PHILCO

Service Bulletin — No. 120B

Location of Compensating Condensers, Models 70 and 90

Model 70

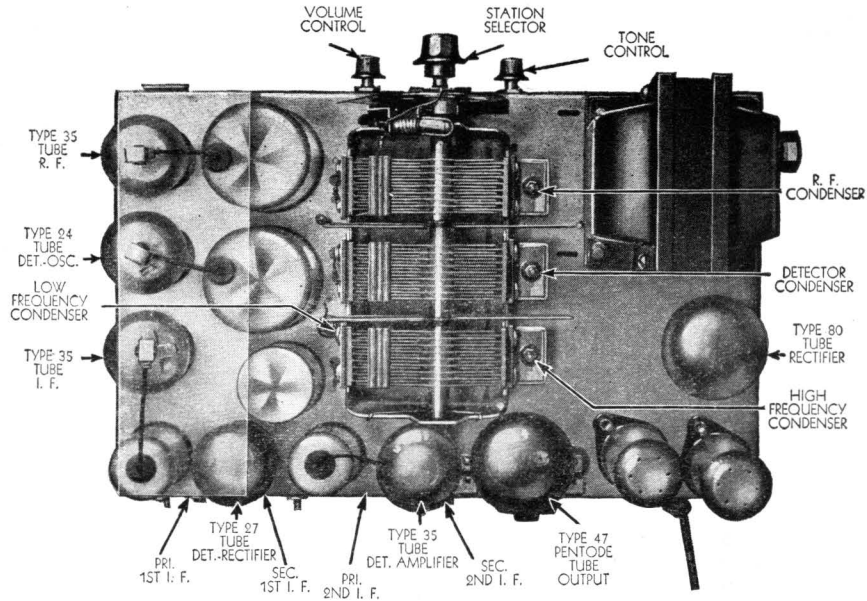
Adjust I.F. compensating condensers at 260 K.C.

Model 90

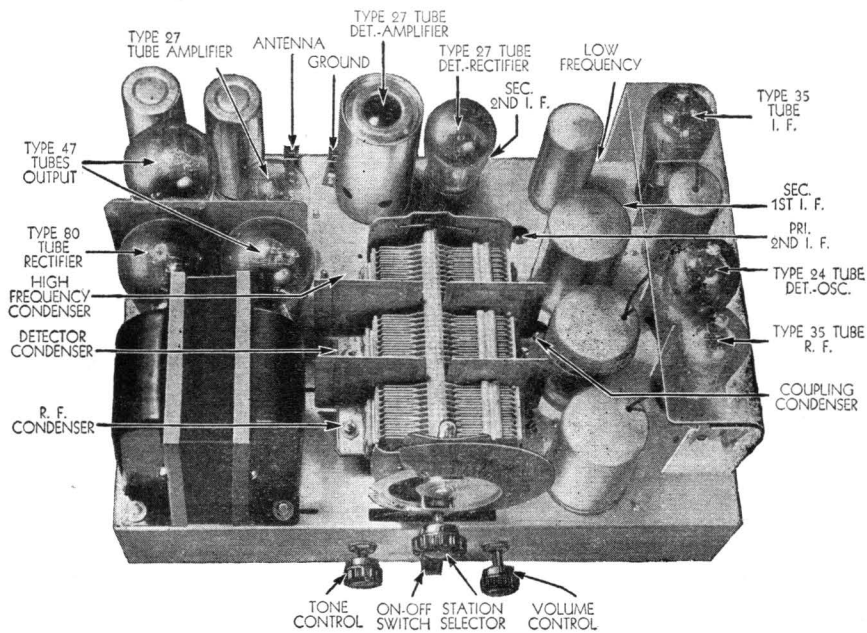
Adjust I.F. compensating condensers and coupling condenser at ~~175~~ 260 K.C.
